## SERVICE BULLETIN INDEX

# **SERVICE BULLETIN No 1 Issue 1 5-10-01**

## **AMMENDED SEAT HARNESS ATTACHMENTS**

# C42FB LOWER SEAT HARNESS TEMPLATE

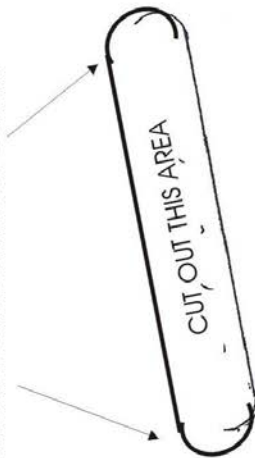
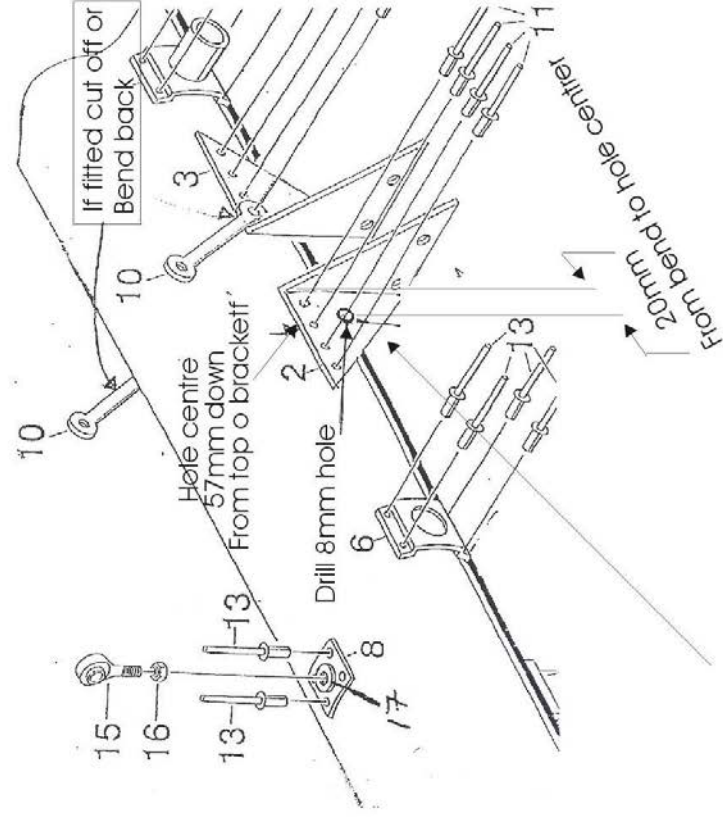
6. Mark the positions on the seat for the Lap-strap entry points using the template provided.
7. Using a suitable tool such as a Dremel cut a slot as per the template on both sides of the seat clean and smooth any sharp edges.  
Reposition the seat and feed the Lap-straps through the slots, slide the anti-chafe heat shrink tubing over the straps to prevent chafing. Install the two each bungs provided into the redundant strap bracket holes.

↑ ATTACH LEVEL WITH TOP EDGE OF SEAT "ARM-REST" PROFILE & WITH EXISTING SEATBELT HOLE "LINED UP" WITH TEMPLATE SEAT BELT HOLE

"LINE UP" ON EXISTING SEAT BELT HOLE

DRILL 8-10MM HOLE EACH END  
FORM INTO A SLOT USING "DREMEL" OR EQUIVALENT CUTTER.

When drilling the 8mm hole place a metal sheet  
Behind the bracket to avoid damage to the main tube

C42FB U/K SERVICE BULLETIN No 3 Issue 1 29-10-2001

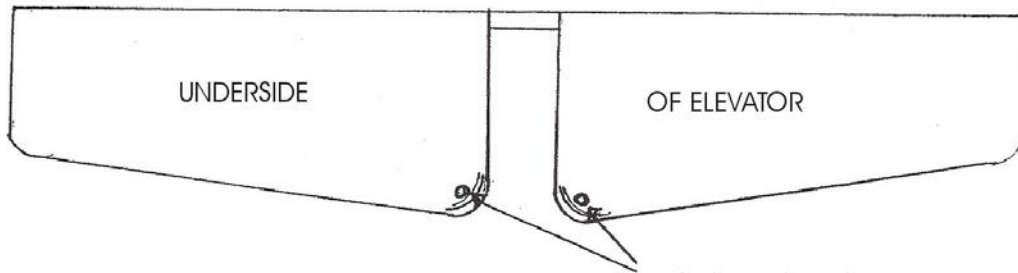
## DRAIN HOLES IN ELEVATORS

Reason: to provide a drain at the low point in the event of water ingress

The best method to carry out this modification is to use a small soldering iron with a pencil tip this will produce a small neat hole in the underside of the envelope "sealed" around its edges. Make the hole around 5 to 6 mm on the underside of both elevators as shown, Note; *when making the drain hole take care not to penetrate the upper envelope.*

Drain holes just inside  
Inboard of trailing edge tube.

## C42FB U/K SERVICE BULLETIN No 7 Issue 1 29-10-2001 SHARP CORNERS ON ELEVATOR CRANK SUPPORT STAYS

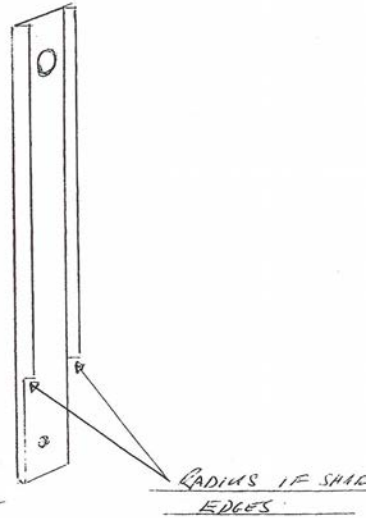
Reason: to eliminate the possibility of cracking

Some of the 2ea U/K support stays Drawing No A81j (6) supplied by Comco Ikarus have sharp 90 deg corners where cut to fit the main tube, this could become a possible fatigue point.

1 If your support stays have sharp corners dress them out using a suitable tool such as a watchmakers round file.

**NOTE: from 2003 all supports were manufactured with the required radius**

### INSTALLATION OF VAPOUR RETURN FOR AIRCRAFT USING "MOGAS"

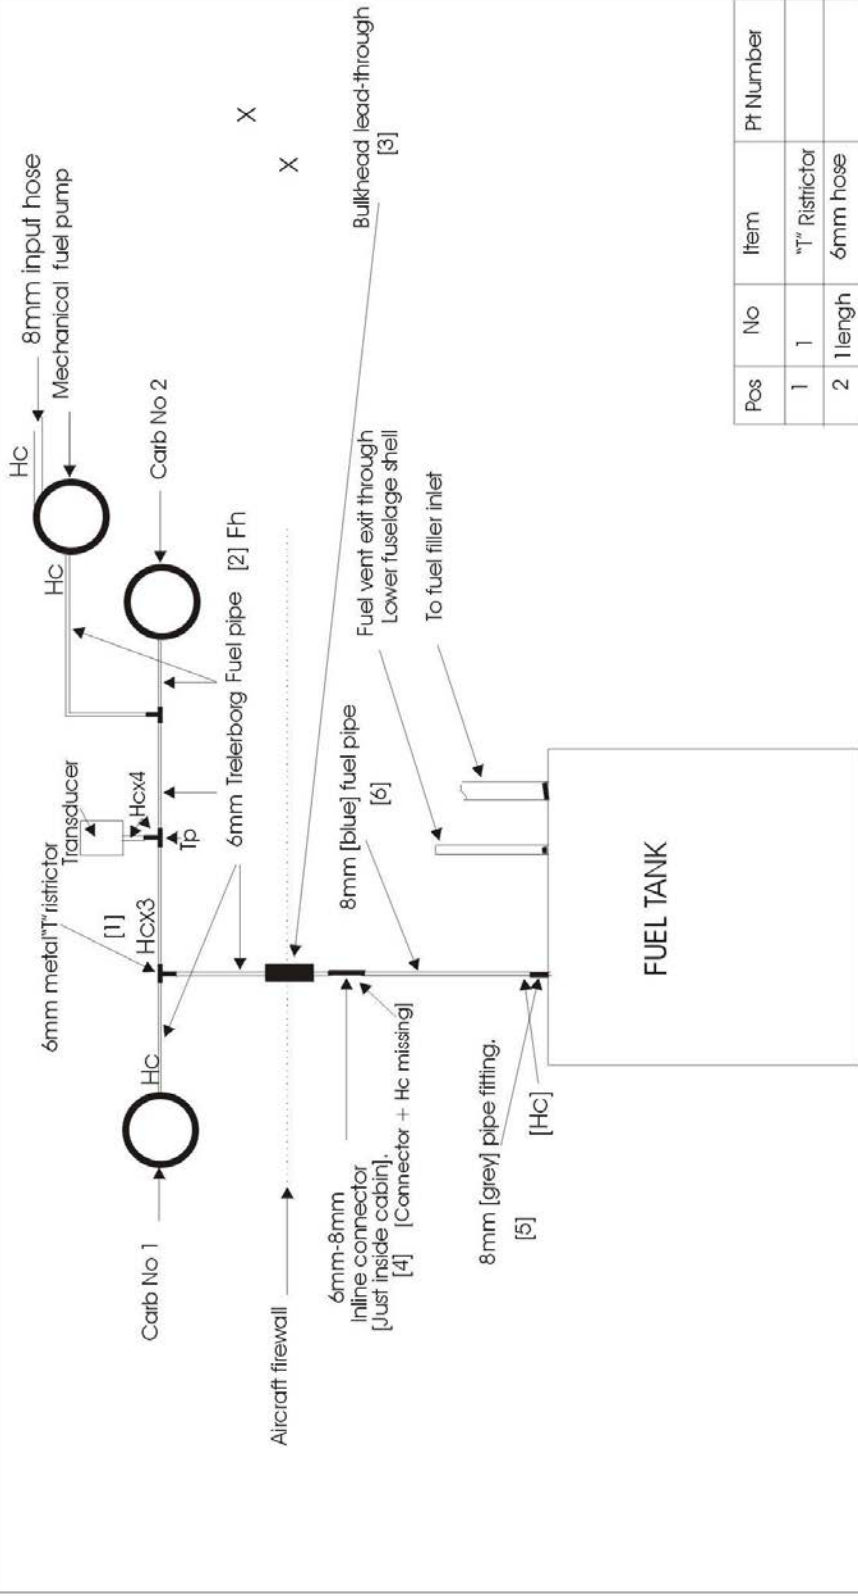
Reason: To decrease the chance of a "Vapour Lock" for aircraft using "Mogas" Fuel

This modification is deemed Mandatory for aircraft using "Mogas" Fuel

A kit of parts is available from Flybuy Ultralights Ltd to carry out this modification comprising of Treleborg Hose [Engine Compartment], Skydrive "T" piece with built in restrictor, Skydrive [blue] hose, 4ea hose clamps for Treleborg hose. 2ea clamps for Skydrive Hose, 1ea insert [Treleborg to Skydrive hose] 1ea screw in tank insert. 1ea Bulkhead Sleeve.

C 42FB U/K
Drawing Number
SB 15a
Issue No 1
Date 5-10-2003

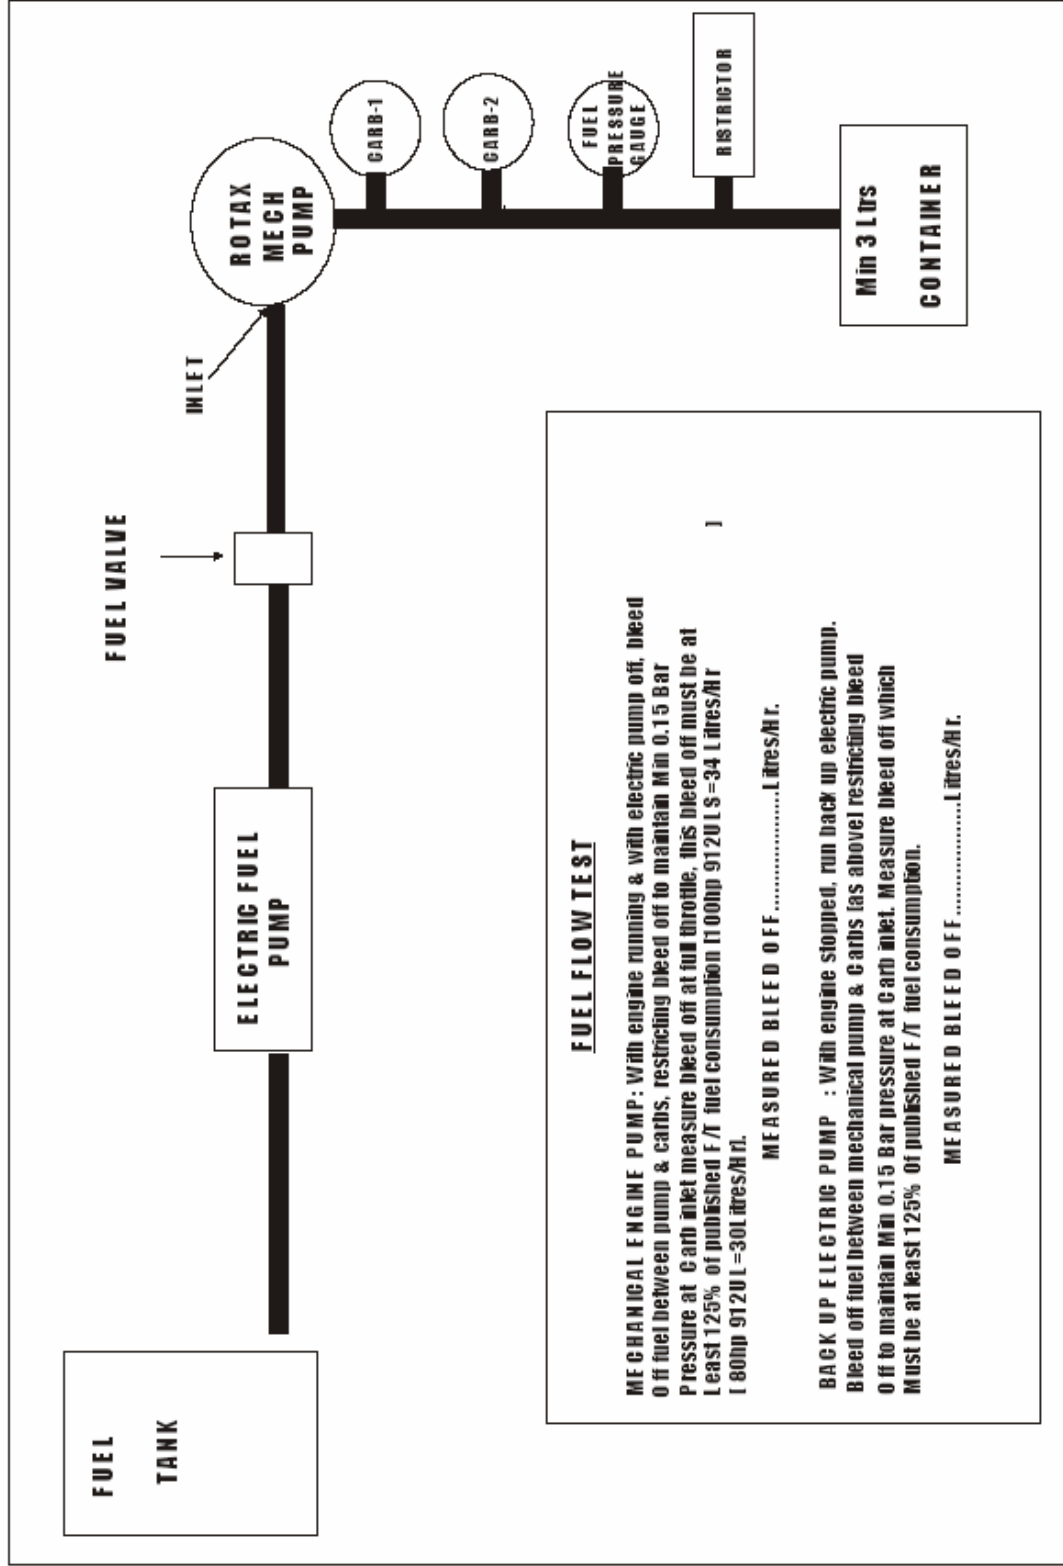
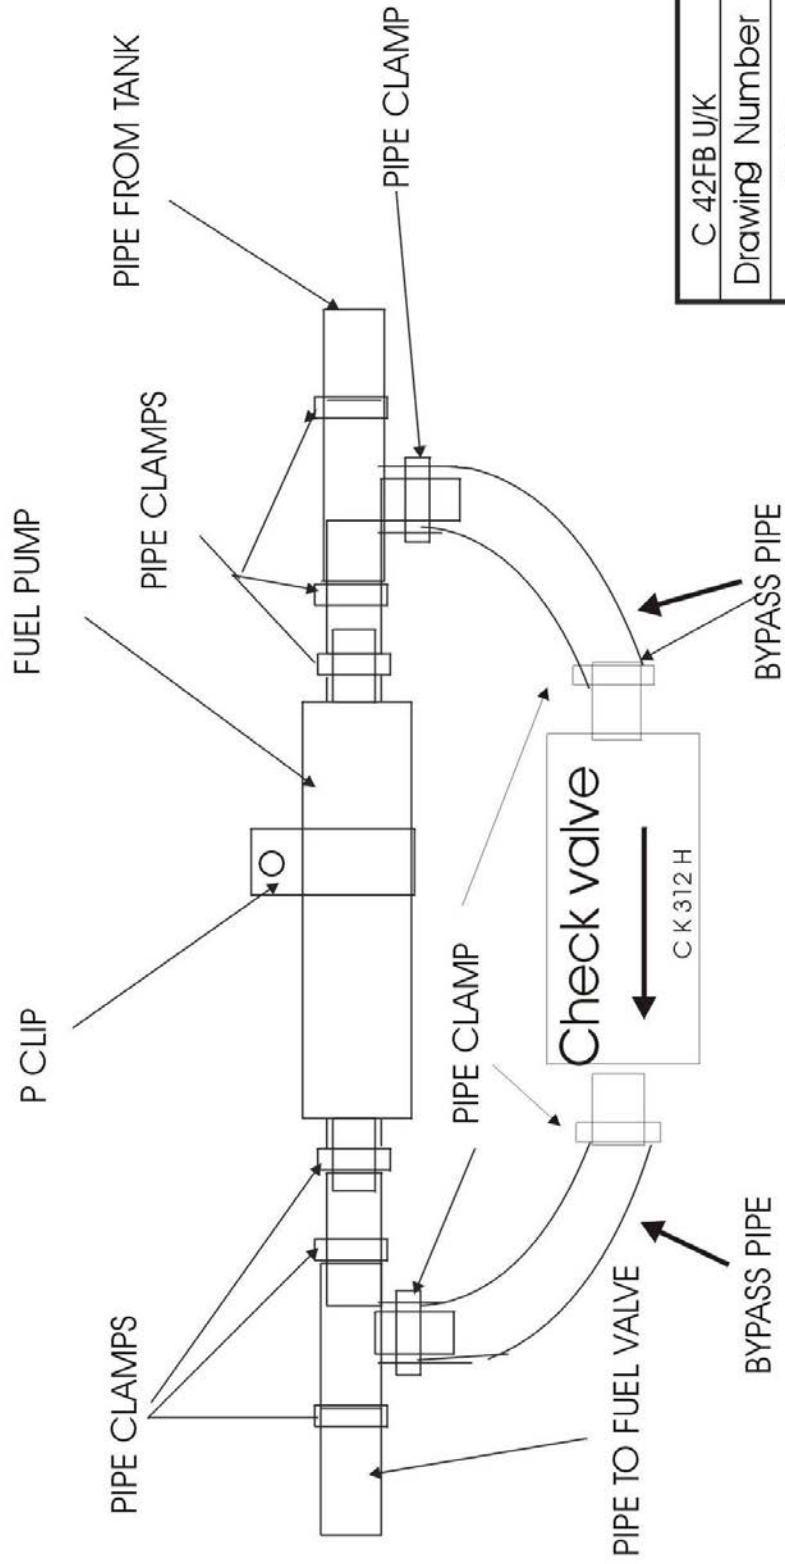
Removal of the restrictor from the pump “bypass line” and insertion of a non return valve into the “bypass line”

- 5) Disconnect the “bypass” hose at the restrictor end and remove the brass restrictor, reconnect the hose and hose clamp. Cut the “bypass” hose in the middle and remove around 15mm from each side of the cut, Note it is important that no debris is allowed to enter the fuel system when carrying out this modification.

- 6) Install the Check Valve CK 312 H and secure each end with a suitable hose clamp, ensure that it is fitted in the direction of flow.
- 7) Re-install the pump with its “bypass” and check valve, ensure the hose clamps are installed and tight, and the “P” clip securing the pump is refitted. Use

## **Elevator Horn Cracking – Factory built C42**

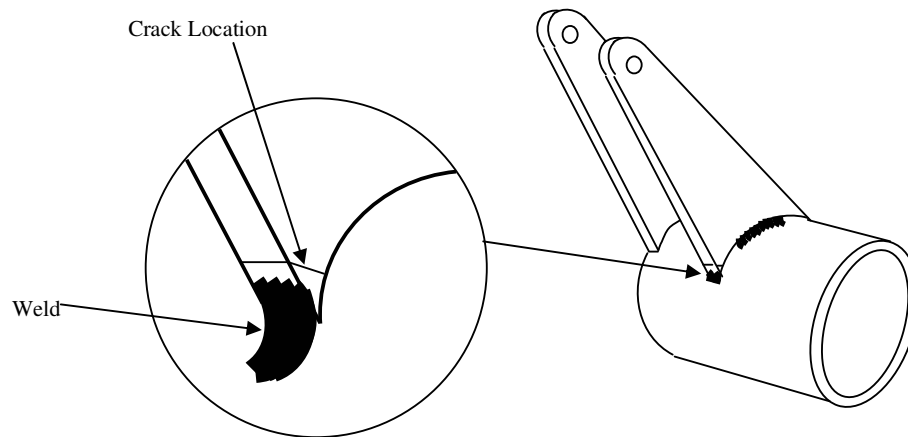
**Nature of Defect** – A short crack has been found on one of the elevator horn plates on a C42 aircraft which had flown 59 hours. The crack appears at the welded junction of the right hand horn plate with the collar tube, at the plate's rear edge, and appears to be associated with a small weld undercut at that point. Drawing 42UKD02.06.00, Issue 26/10/2002, Elevator Horn Assembly, refers.

**Airworthiness Implications** – If the crack propagates through to the adapter tube, this places an increased parting load on the circumferential weld further forward. This in turn may crack. Although the horn consists of two plates, giving some degree of redundancy, the loss of one plate would significantly reduce the safety margin of the elevator control strength.

- (a) Using a dye penetrant crack detection method, inspect the elevator horn for cracks before next flight. Inspect both arms of the horn at all welds. Pay particular attention to the front and rear of the elevator arms at the points where they meet the tube.
- (b) If a crack is found, ground the aircraft and remove the elevator horn assembly. The procedure for this is given below. Replace the part with the modified version having an improved weld pattern; the part is available from Flybuy Ultralights, Part No. 42UKD02.06.00 Issue 10/12/03.

### **Elevator Horn Cracking – Kit Built C42,**

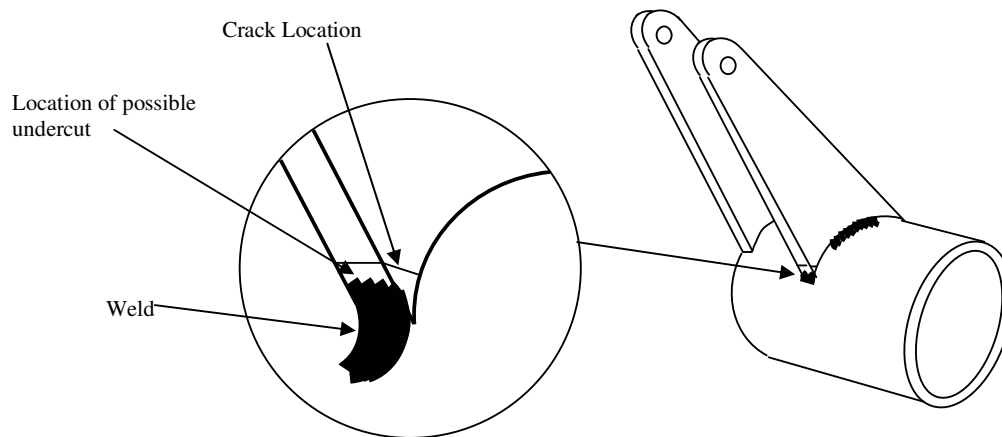
**Nature of Defect** – A short crack has been found on one of the elevator horn plates on a C42 aircraft which had flown 59 hours. The crack appears at the welded junction of the right hand horn plate with the collar tube, at the plate's rear edge, and appears to be associated with a small weld undercut at that point. Drawing 42UKD02.06.00, Issue 26/10/2002, Elevator Horn Assembly, refers.

**Airworthiness Implications** – If the crack propagates through to the adapter tube, this places an increased parting load on the circumferential weld further forward. This in turn may crack. Although the horn consists of two plates, giving some degree of redundancy, the loss of one plate would significantly reduce the safety margin of the elevator control strength.

(b) If a crack is found, ground the aircraft and remove the elevator horn assembly. The procedure for this is given below. Replace the part with the modified version having an improved weld pattern; the part is available from Flybuy Ultralights, Part No. 42UKD02.06.00 Issue 10/12/03

## **Stub Axle Shock Absorber Attachment Cracking – Ikarus C42**

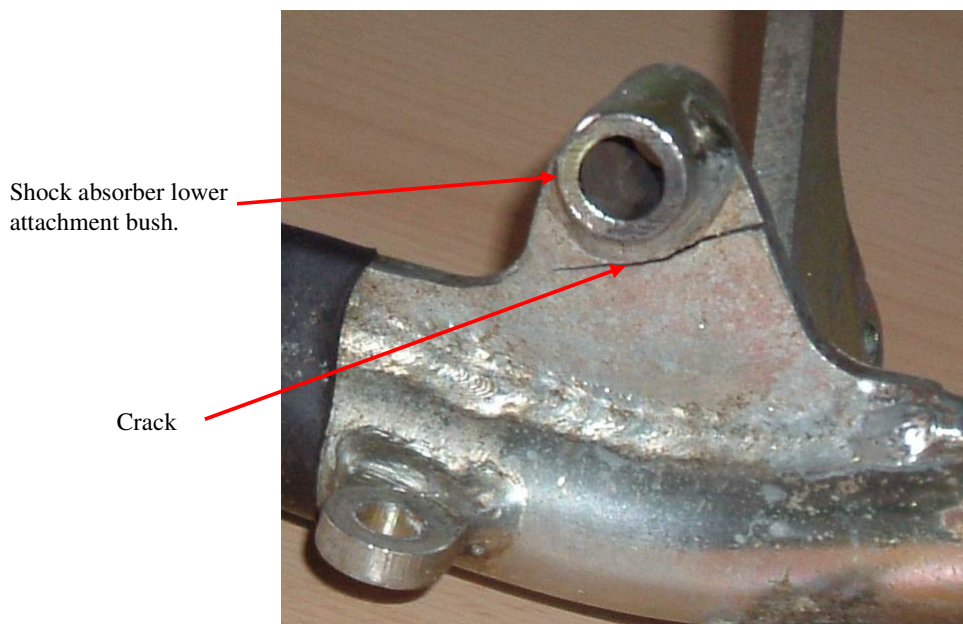
**Nature of Defect** – Each steel stub axle of the C 42 (UK) is attached to its shock absorber by a small 6mm thick vertical plate, welded to the stub axle. Almost all the braking torque is reacted by the attachment of this plate to the base of the shock absorber.

Two examples of stub axles on German aircraft, (which have 5mm thick plates), have been found to have cracks near to their junctions with the shock absorber. These are shown below. The German aircraft had completed around 200 hours; number of braked landings is unknown.

**Airworthiness Implications** – If the crack propagates to the inboard side of the lug, then collapse of the undercarriage is likely during the next braked landing.

- (a) Remove the wheel spats and clean the stub axle area. Using a magnifying glass inspect the area around the lower suspension

mounting point for signs of cracking. It may be necessary to jack up the aircraft and remove the lower shock absorber mounting bolt in order to inspect the area properly. Both axles must be checked.

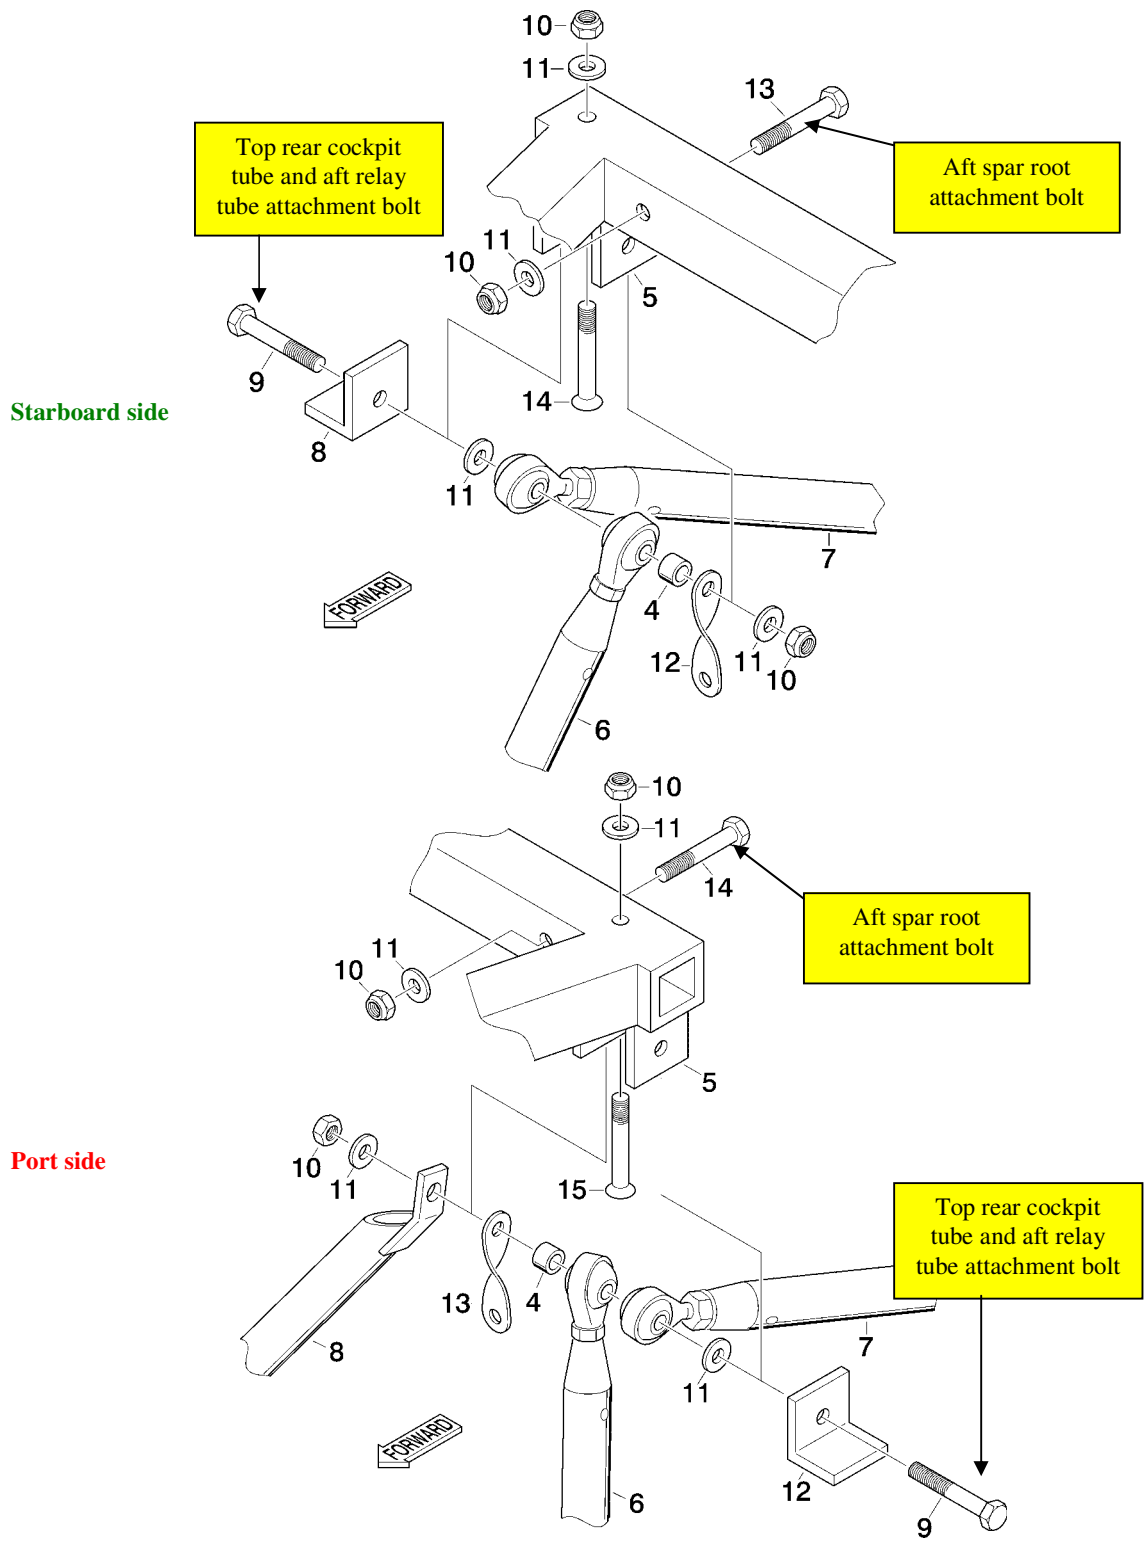
**Nature of Defect** – Possibility of aft spar root attachment bolts and top rear cockpit tube and aft relay tube attachment bolts fitted with load bearing on threaded section of bolt.

**Airworthiness Implications** – Load bearing on threaded section of bolt reduces shear load capabilities of bolt and increases wear on mounting attachment.

- (a) View diagrams on next page which highlight affected bolts.
- (b) Remove nuts and washers (items 10 & 11) from both bolts and check that some shank is visible. If no shank is visible then the bolts must be replaced with correct length bolts.
- (c) Contact Aerosport Ltd for correct bolts and replacement nuts.
- (d) Inspect fittings for signs of wear or fretting from threaded section of bolt. Contact Aerosport Ltd if any wear is detected.
- (e) If the bolt length is acceptable then re-fit washers and fit new nyloc nuts, which are available from Aerosport Ltd. Re-tighten the nuts to a torque of 15Nm.
